# Planned Construction Of Some Army Dining Facilities In West Germany Can Be Canceled

GAO/PLRD-83-72  
MAY 13, 1983

B-207912

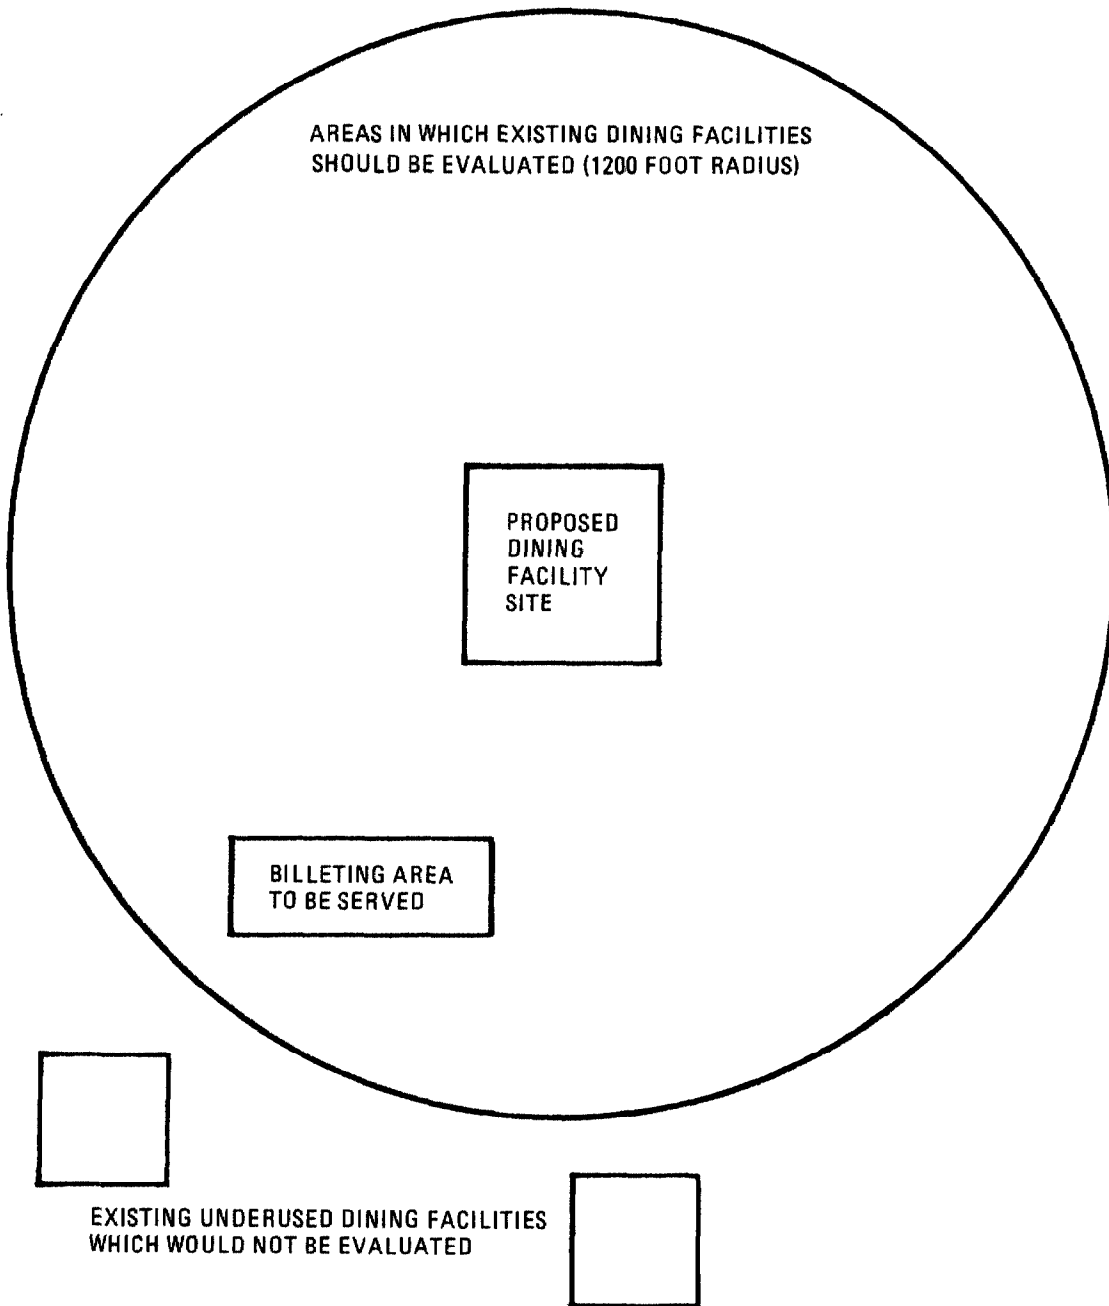
Evaluation of the capacity and use of only those existing dining facilities within 1,200 feet of a planned dining facility project site will not necessarily insure maximum use of both new and existing facilities. For example, as the chart on page 19 shows, two or more dining facilities may be within 1,250 feet walking distance of a billeting area, but not within 1,200 feet of the site of a planned dining facility. Exclusion of one or more of these existing facilities would not insure maximum and efficient use of all existing and planned facilities which could support a particular billeting area. Moreover, depending on the location and amount of unused capacity in existing facilities, it might be more economical and efficient to redesignate the dining facilities which enlisted personnel from particular units would use.
